RE: Ex Parte Communication, Docket EERE-2017-BT-TP-0020, Friedrich Air Conditioning, Regarding Test Procedures for Single Package Vertical Units and Docket EERE-2021-BT-TP-0030 regarding Test Procedures for Consumer Central Air Conditioners and Heat Pumps.

On March 31, 2022, representatives from Friedrich Air Conditioning (FAC), a wholly-owned subsidiary of Rheem Manufacturing Company, met with members of the Department of Energy (“Department”) to discuss the subject matter. See below for the complete attendee list. One of the primary purposes of this meeting was to review Friedrich’s Vert-I-Pak® line of products used in commercial applications. For example, FAC discussed DOE’s proposed definition found on page 2495 Federal Register / Vol. 87, No. 10 / Friday, January 14, 2022 / Proposed Rules, which states.

Figure 1. Typical FAC Vert-I-Pak® Installation

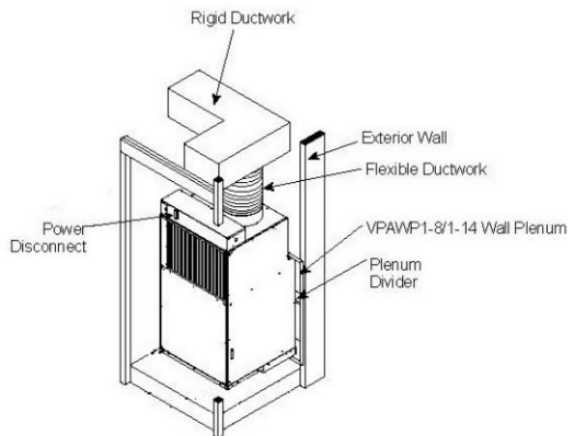
- Friedrich Vert-I-Pak® units have been tested and listed according to AHRI 390 since 2005. Since most of these units are installed in hotels and other commercial locations, the unit is installed within a closet. It has a free unducted intake and a short discharge duct (typically less than 15 ft) into the conditioned space. Thus, these units are installed in applications where the External Static Pressure (ESP) is only due to the discharge duct (unlike CACs) and with short duct lengths. The exterior wall is designed explicitly with a large cutout area so that the outdoor heat exchanger can intake and exhaust outdoor air. Figure 1 shows a typical installation.

- Friedrich Vert-I-Pak® installations are typically no more than 500 square feet. The typical American hotel room is about 350 square feet.
- Furthermore, since this change requires a change in the minimum efficiency, the current install base will be left without any replacement option. Replacements for FAC SPVAC and SPVHP involve high construction costs as the unit size, and method are designed into the building (as described earlier). Any change would require a substantial change to building infrastructure and might not be possible without compromising the integrity of the building structure.
